RE: The Exchange Lot 1
Project number: SP23-080

Please find below our responses addressing the Town's 1st Submittal Review comments for the proposed project located at 19590 Mainstreet, Parker, CO 80138.

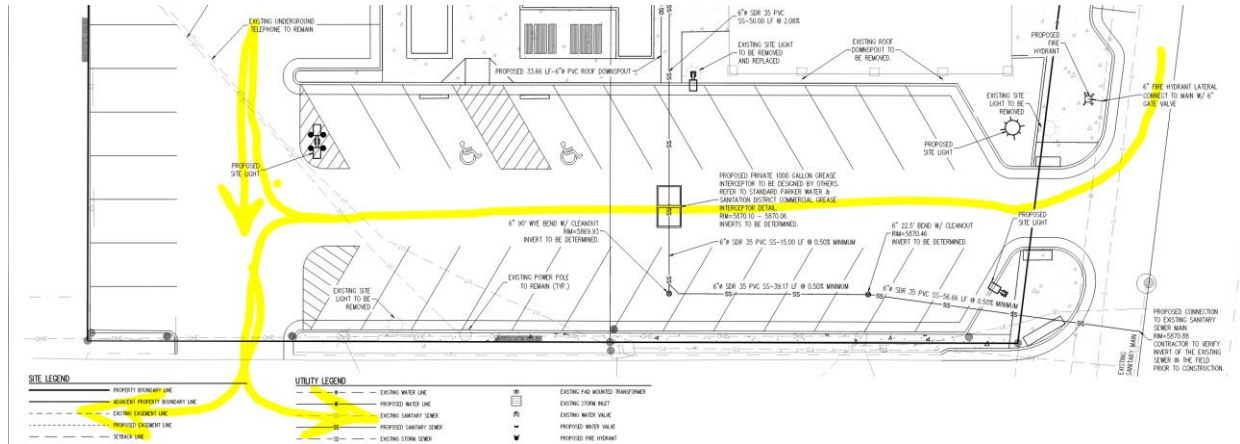
8. **Utility Plan Set:** The applicant shall provide a utility plan that identifies the locations of all utilities on the site (including natural gas and electricity). The overall utility plan shall identify the location of the required fire hydrant(s) and the required underground fire line UFL). **The plan set shall identify the UFL on the plan (not just providing a note) while providing the length and diameter of the UFL (as measured from the T at the water main to the flange within the building).**

Note – The UFL shall have its own tap; domestic water and the required fire hydrant shall have separate taps.

Response: Length, diameter, and tap for the fire line have been identified
